SUBJECT: LICENSEE'S 10 CFR 50.59 EVALUATION OF MAIN STEAM LINE BREAK
(MSLB) REANALYSIS AND EFFECT ON ISOLATION VALVE CUBICLE
(IVC) AND REACTOR CONTAINMENT BUILDING (RCB)
(TAC NOS. M98914 AND M98915)

Originating Document No. USGE 95-0013Revision No. 0TITLE CN-1462 Revise analysis of the Main Steam Line
Break in the IVC and PCB

TITLE MSLB Blowdown Model for IVC

Change Number 1962 Date 3/29/95
 Originator Charles Albany Dept NPLA
 Change Description Main Steam Line Break in IVC

Figure 6.2.1.2-25

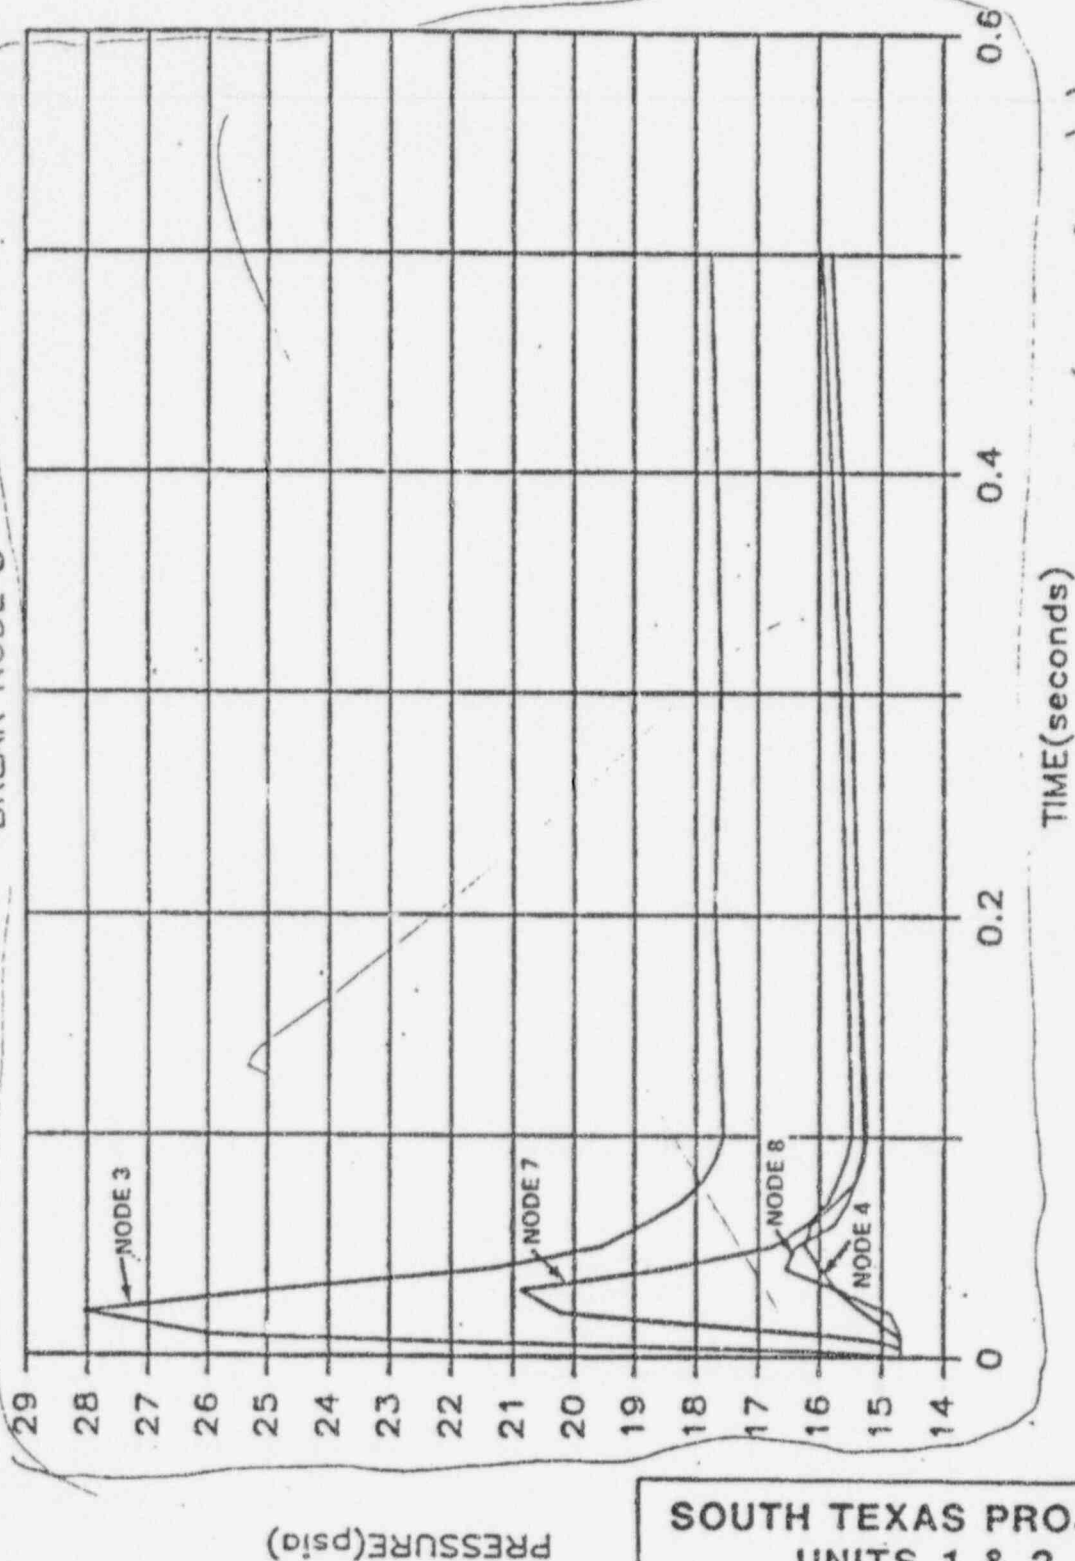
Replace with attached
Figure B
